DESIGN <i>PH</i>	DRAWN BY <i>PH</i>	DART AEROSPACE LTD HAWKESBURY, ONTARIO, CANADA	
CHECKED <i>[Signature]</i>	APPROVED <i>[Signature]</i>	DRAWING NO. DSI 9346	REV. B SHEET 1 OF 1
DATE 06.10.10		TITLE DEVIATION ON D206-667	SCALE NTS
A	06.08.08	NEW ISSUE	
B	06.10.10	ADD B28679, B28682, B28683

DART SERVICE INSTRUCTION

TO AMEND INSTALLATION INSTRUCTIONS IIN-D206-667 REV. C
REF. CANADIAN STC: SH01-5
REF. FAA STC: SR01304NY

FIGURE 1 – INSTALLATION OF DART CROSSTUBES ON BHT/AAI SKIDTUBE

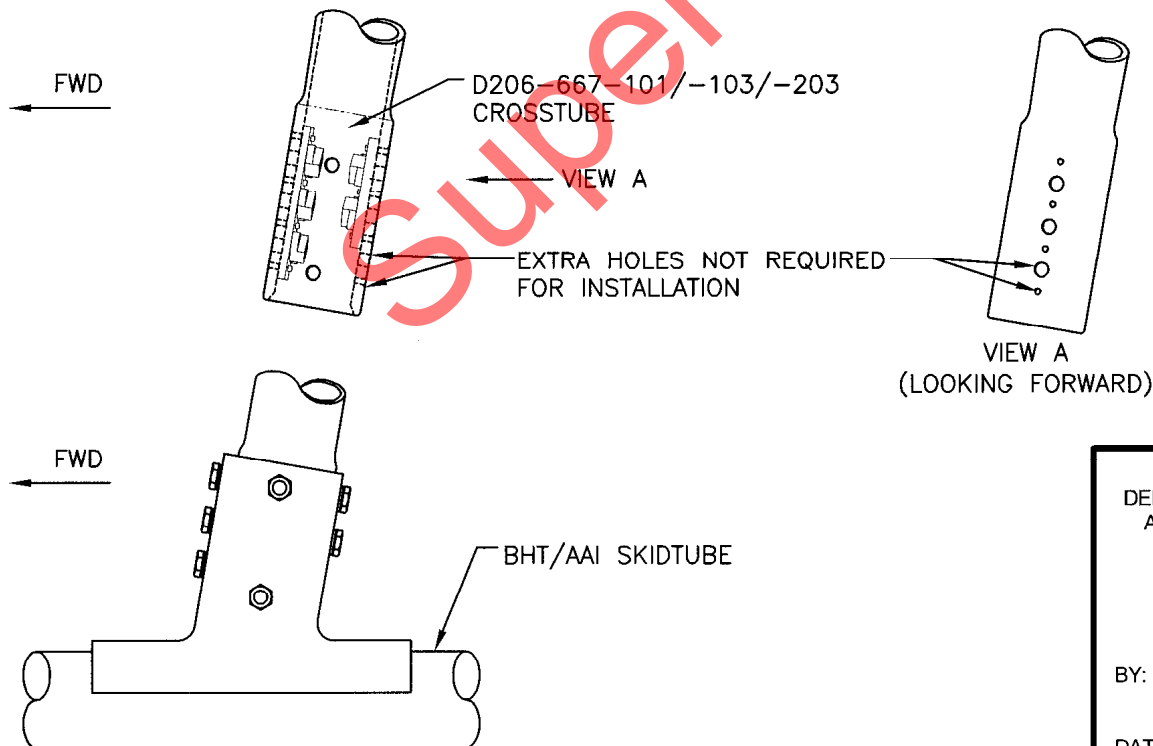
THE FOLLOWING D206-667-101/-103/-203 CROSSTUBES HAVE EXTRA HOLES DRILLED ON THE AFT SIDE OF THE CUFFS. THIS HOLE IS NOT REQUIRED FOR INSTALLATION OF DART CROSSTUBES ONTO BHT/AAI SKIDTUBES AS SHOWN IN FIGURE 1.

CUSTOMERS RECEIVING CROSSTUBES AT CHG 002 PRIOR TO 06.08.08 SHOULD CONTACT DART FOR DISPOSITION IF INSTALLING THE DART CROSSTUBES ONTO BHT/AAI SKIDTUBES PER IIN-D206-667 REV. C.

CUSTOMERS RECEIVING CROSSTUBES AT CHG 002 PRIOR TO 06.08.08 TO BE INSTALLED WITH DART SKIDTUBES MAY FIND THAT THE SUPPORTS HAVE BEEN INSTALLED BACKWARDS. THE SUPPORTS SHOULD BE REMOVED AND RE-INSTALLED PER ICA-D206-667.
